## 2. SITE CHARACTERISTICS

### 2.1 Geography and Demography

#### 2.1.1 Site Location and Description

**Figure 2.4-3 Location of the intake from and discharge into the submerged UHS pond**

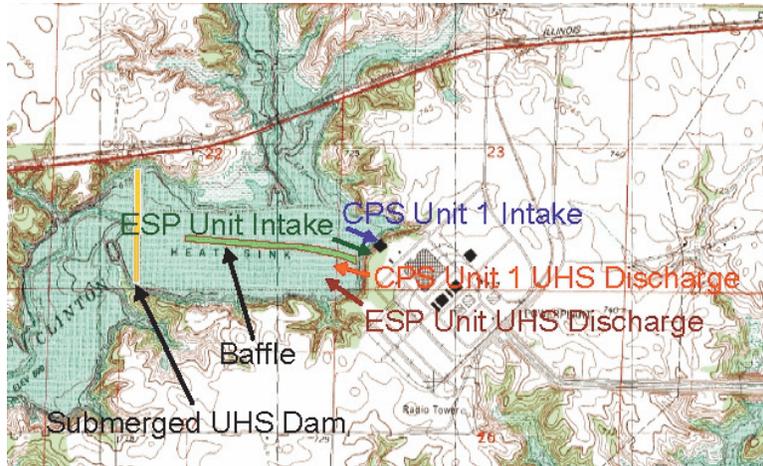
In Request for Additional Information (RAI) 2.4.1-1, the staff asked the applicant to provide survey coordinates (including elevations) for the bounding areas of all ESP facility safety-related structures, including intake tunnels and piping corridors. The staff also requested that the applicant provide coordinates of existing aquifers in bounding areas, particularly perched aquifers. In response to RAI 2.4.1-1, the applicant provided an updated figure to replace Figure 1.2-4 in Chapter 1 of the site safety analysis report (SSAR). The applicant stated that this figure shows the approximate location of safety-related structures, along with a grid system overlaid on the figure.

**Figure 2.4-4 The watershed draining into Clinton Lake, delineated manually using topographic contours**

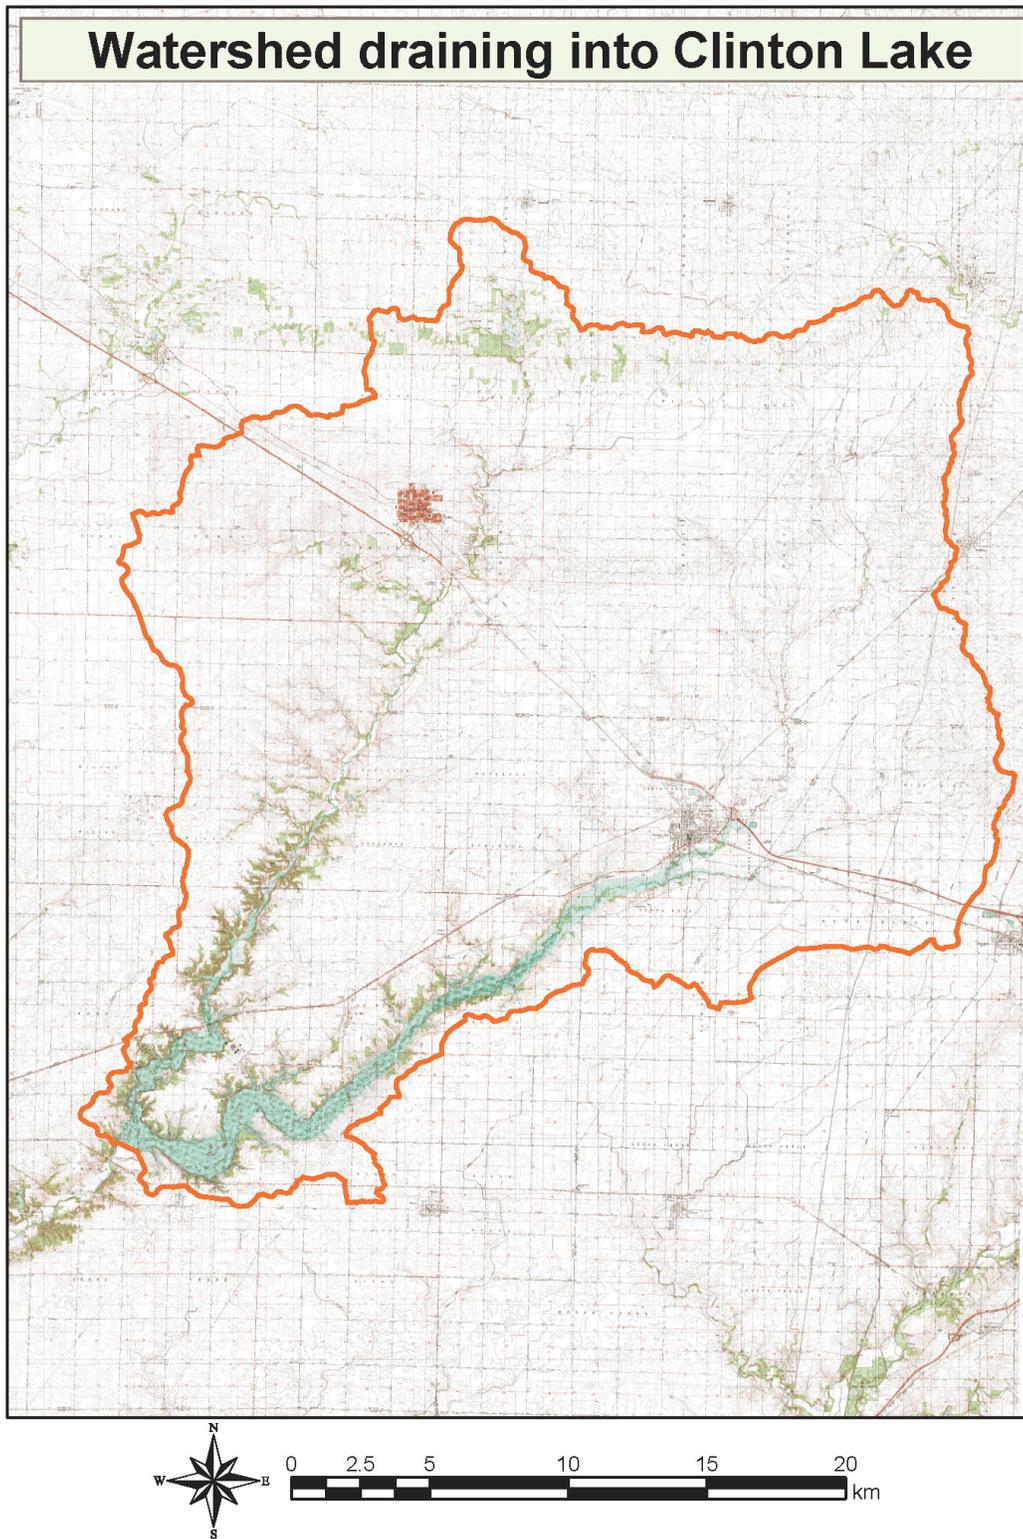
In SSAR Section 2.4.1.2, the applicant states that the catchment area of Salt Creek above Clinton Dam is about 296 mi<sup>2</sup>. The staff manually delineated the watershed draining into Clinton Lake using USGS topographic maps (Figure 2.4-4 of this SER). The staff determined the area of the manually delineated watershed as 289.2 mi<sup>2</sup>. The staff-estimated catchment area of Salt Creek above Clinton Dam is approximately 2.4 percent less than that reported by the applicant.

In RAI 2.4.1-4, the staff requested that the applicant provide information regarding proposed land use changes in the watershed upstream of Clinton Lake. These changes might result in increased bed load in the tributaries upstream of Clinton Lake and increased sediment deposition in the submerged UHS pond. In response to RAI 2.4.1-4, the applicant stated that it does not have any information regarding proposed land use changes upstream of Clinton Lake. The staff determined that, for site suitability evaluation, the applicant needs to provide an authoritative source that may include State or county planning officials who can either provide details of a development plan in Clinton Lake's watershed or verify the absence of such a plan. This is **Open Item 2.4-3**.

The staff also disagreed with the applicant's statement that increased impervious area within Clinton Lake's watershed will result in a reduction of soil erosion and sediment discharge to tributaries. An increase in impervious area is likely to increase the volume of surface runoff, as well as decrease the time required to reach peak runoff in the watershed. Because of quicker and greater runoff, it is more likely that soil erosion will increase, not decrease. Should the resulting increased soil erosion decrease the submerged UHS volume in the lake, the staff would have to examine whether or not the UHS capacity is adequate. Therefore, the applicant needs to provide additional justification for why an increase in impervious area will not increase soil erosion. This is **Open Item 2.4-4**.

**Figure 2.4-11 Clinton Power Station site and fetch length**

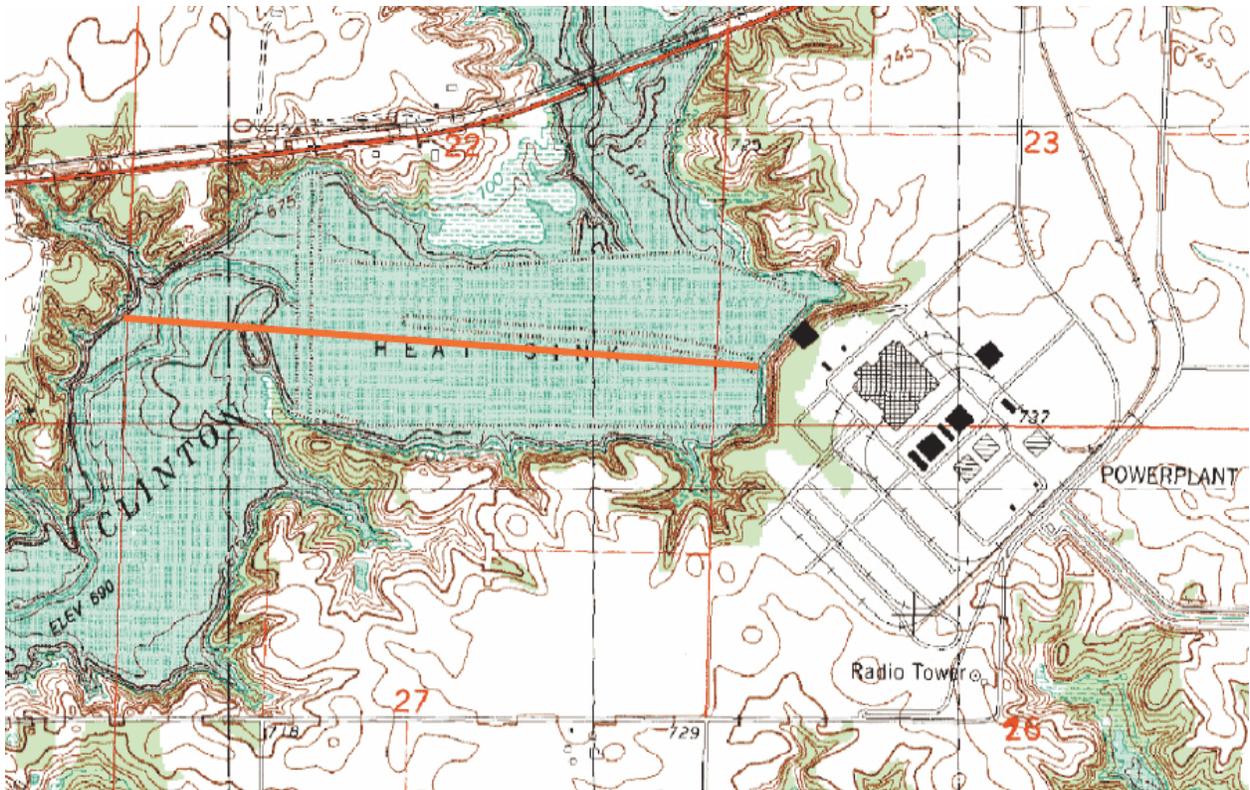
The following describes the independent evaluation performed by staff to estimate seiche effects. Fetch length is one of the key parameters for determining wind setup and is generally based upon the longest straight-line distance from the site to the opposing shore. Although the site is approximately 3 mi from the dam and 10 mi from the upstream end of the reservoir, the longest straight-line distance to the opposing shore is approximately 6340 ft (see Figure 2.4-11 of this SER).

The staff estimated the period of oscillation resulting from seiche, along the fetch length line shown in Figure 2.4-11 of this SER, based on the theory for free oscillation of water of uniform depth and temperature in a rectangular basin (B.W. Wilson, "Seiches," (*Advances in Hydoscience*, Volume 8, Academic Press: New York, 1972)):
